Powerco's submission on EDB DPP4 Draft Decision

Powerco response to DPP4 draft decision

Commerce Commission

12 July 2024

Figure 1 & 2 - Average planned SAIDI and SAIFI for non-exempt EDBs

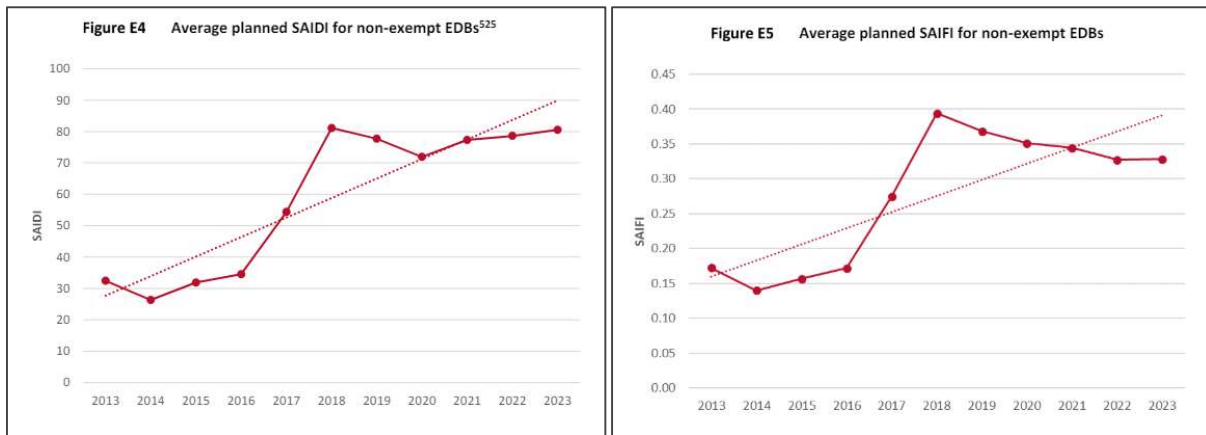
100. We support the draft decision to shorten the reference period for planned interruptions to better reflect modern safety standards (reduced live line work) and the increase in total work over that period. A five-year reference period aligns it to the reference period for capex to better account for the growth in volume of planned work that is expected, in which the corresponding planned SAIDI will also follow this upward trend. A historical average will always lag, which is not fit for purpose.

101. Failing that, should the Commission maintain the seven-year reference period, we recommend excluding data from 2017 for the final decision, resulting in a 7-year reference period of 1 April 2018 – 31 March 2024.

The 2017 data does not accurately reflect planned interruption practices employed by EDBs, which coincides with safety led (WorkSafe) move away from live line work. This is illustrated in figure 1 and 2 below, where 2017 data is significantly below the average planned SAIDI and SAIFI for EDBs since 2018.²⁸
